From: Richard Winn
Sent: 02 June 2015 15:00
To: Jill Bastow
Subject: Sunny Bank Barn, Hackness NYM/2015/0209/FL

SUNNY BANK, HACKNESS

Proposed alterations to existing access

Scale: 1.200 date 04.04.13 dwg:no.1300-5B : amended 02.06.15

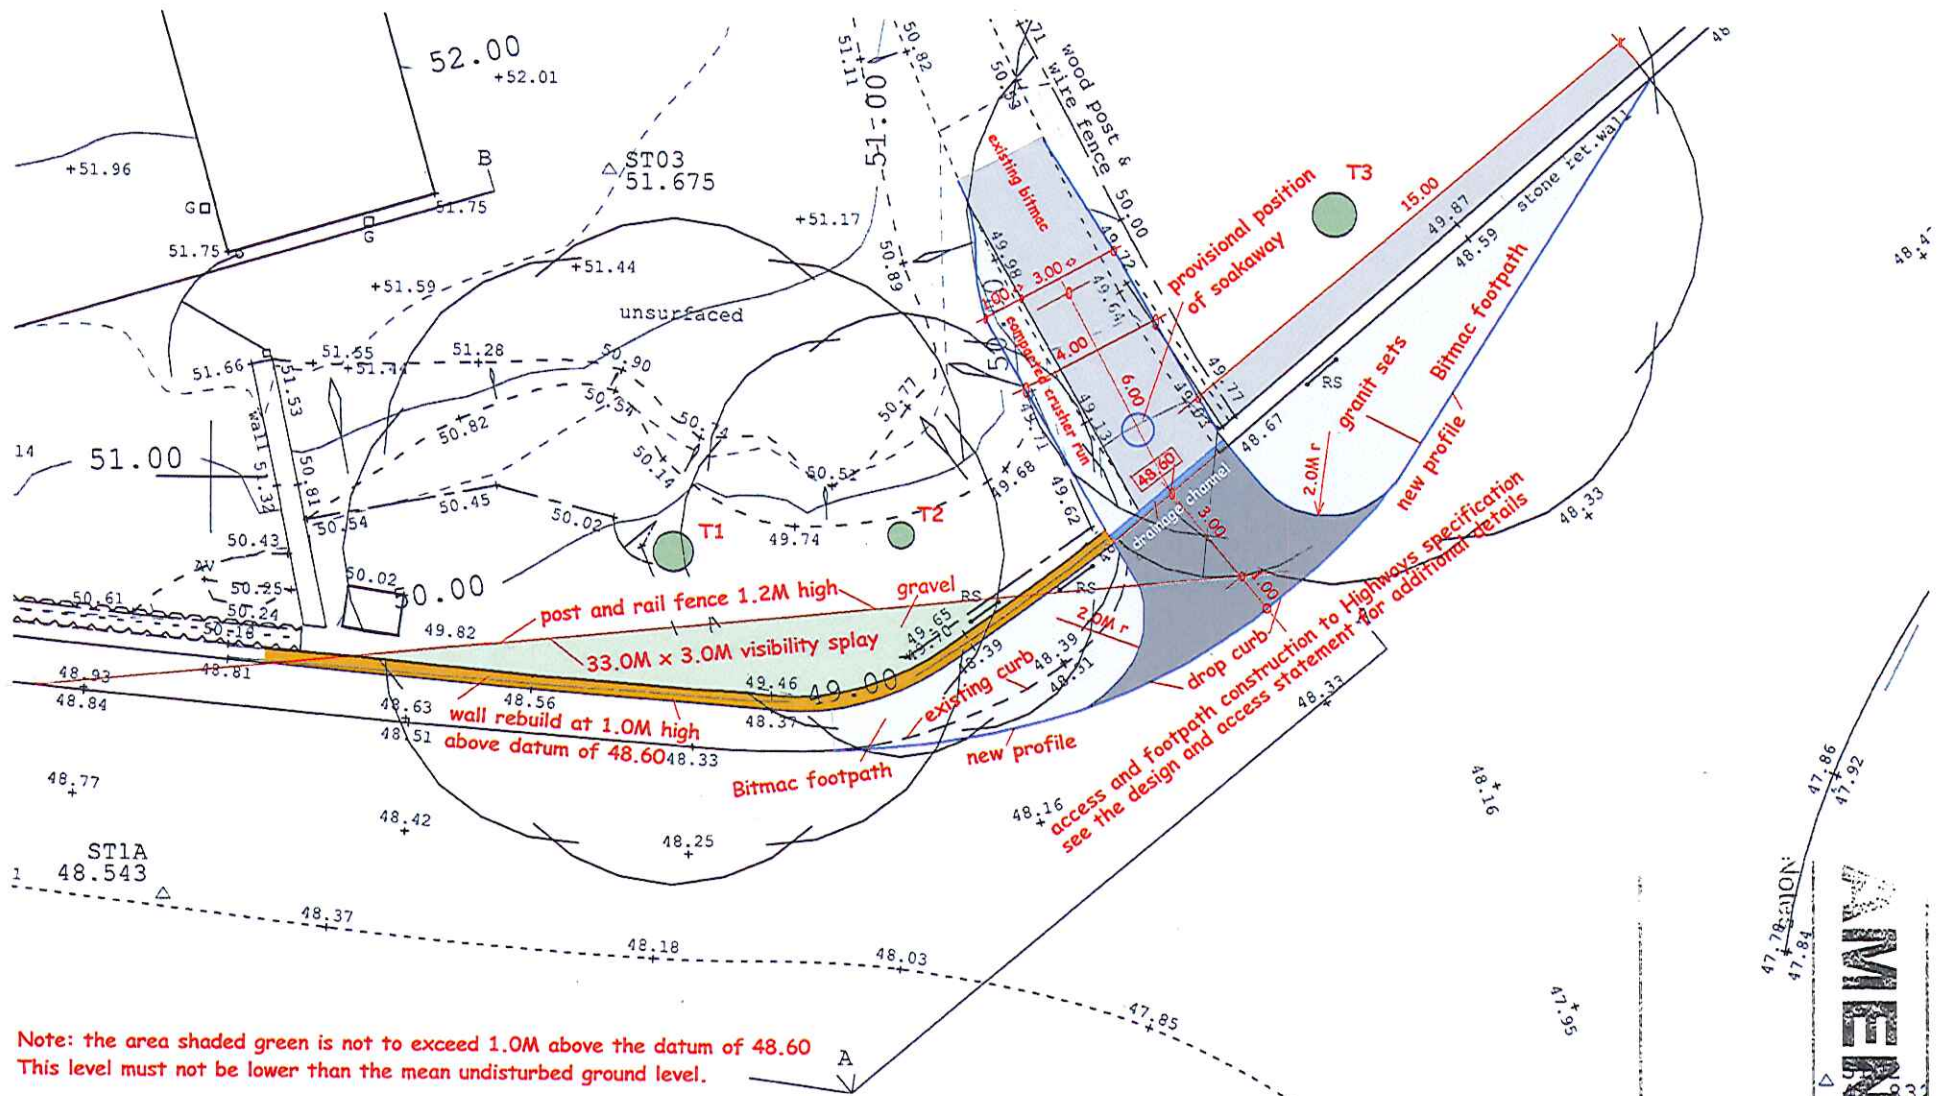
Further to our recent phone conversation, I attach a copy of drawing no. 1300-5B amended to include:

1. a timber post and rail fence in lieu of the close boarded fence to define the visibility splay and,
2. the surfacing material of the altered access within the site.
